Memorandum

Message Ref: Mt Munro Windfarm section 92 responses

Dear all please find below the ecological responses to the various ecological Section 92 requests and several of the Erosion and Sediment control queries also.

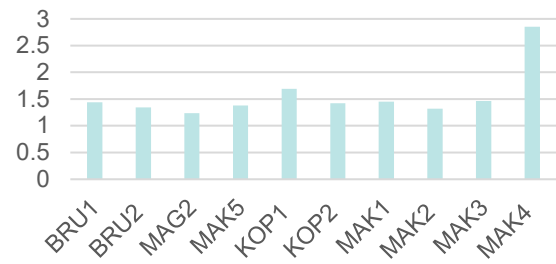
In relation to ecological values, the assessment of rarity contained in Appendix 6 incorrectly labels the status of longfin eel to be not threatened, when it does in fact have a threatened status. There is no science basis for this, and the position taken has been used to justify a low rarity value for all waterways assessed. A more appropriate valuation would be moderate rarity for all waterways where longfin eel occurs due to its threatened classification. Please provide justification on why this classification has been used.

The Appendix correctly labels long fin eel as At Risk - Declining (Appendix 6, page 1, rarity and distinctiveness”).

However, it then goes on to explain why long fin eel, in this catchment and indeed in most catchments around New Zealand, are not considered “rare” for the purposes of value.

This is because rarity is a function of numeric abundance and / or frequency of presence. Long fin eel is one of the most ubiquitous species in the fish records and one of the most abundant and therefore regardless of its threat classification it is not rare.

Given ecological value is not a statutory assessment the assessor is entitled to provide evidence-based decisions as to the fit or not of a species to a value criteria - we have done that.

The presence of long fin eel in any stream does not, in our opinion, render the stream habitat as of moderate habitat or as “moderate rarity” under rarity.
